Request for Class II Permissive Change

FCC ID: VG8XM245AYY-PV4

Please be notified that we, the undersigned, **Guangdong Midea Kitchen Appliances Manufacturing Co.,Ltd.** declare that the reasons for this class II permissive change are as below:

Original Mother board-top view

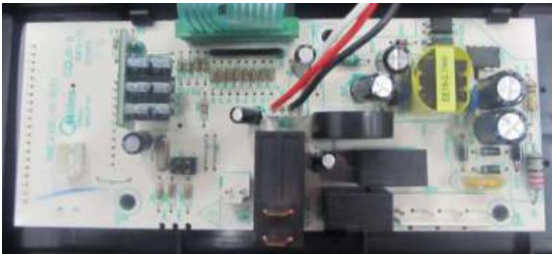
1. Changed mother board as below.

Note : They have the same fuction& theory with the original. Only for some components and PCB Layout differences.
